TELEPERM ME Product Information 6DS1 412-8RR Continuous Controller Module, 2-channel

Settings of module 6DS1 412-8RR which replaces 6DS1 412-8CC/DD/DE

Settings of module 6DS1 412-8RR which replaces 6DS1 412-8AA

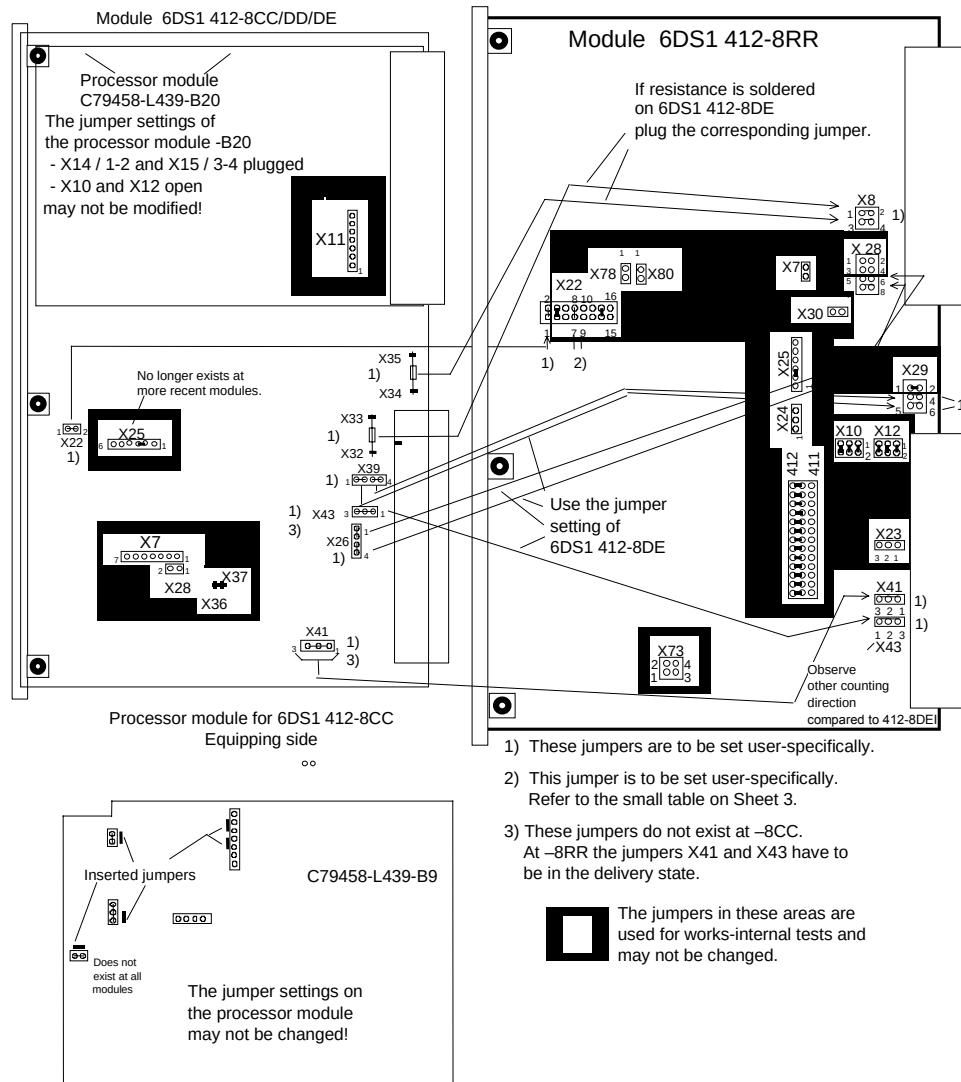
- If module 6DS1 412-8RR is used as the replacement module for 6DS1 412-8DE, jumper X22/7-8 has to be plugged. The module then signals towards GET-TM EA that it is firmware variant E. The version is formed from the version of the -8RR variant by adding 20: for example: R.02 -> E.22.
Refer to the small table on Sheet 2/3.

- If module 6DS1 412-8RR is used as the replacement module for 6DS1 412-8DD, jumper X22/9-10 has to be plugged. The module then signals towards GET-TM EA that it is firmware variant D. The version is formed from the version of the -8RR variant by adding 20: for example: R.02 -> D.22.
Refer to the small table on Sheet 2/3.

-8RR Jumper X22/	Module reports as FW variant
7-8 Plugged	E *)
7-8 Open	R
9-10 Plugged	D *)
9-10 Open	R

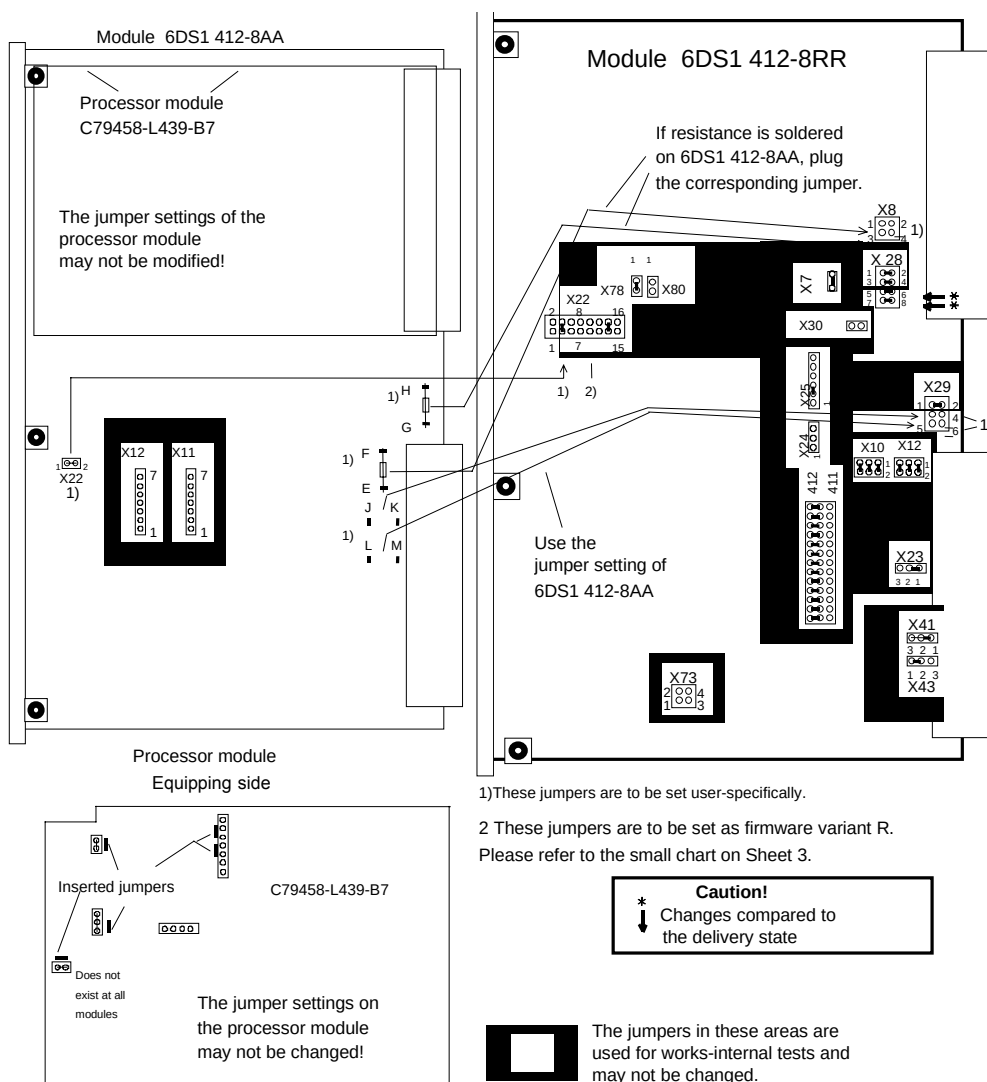
- If the module 6DS1 412-8RR is used as the replacement module for 6DS1 412-8AA/CC, neither jumper X22/7-8 nor jumper X22/9-10 may be inserted. The module then signals that it is firmware variant R.

Caution!
 * Changes compared to the delivery state
 Only for 6DS1 412-8AA!
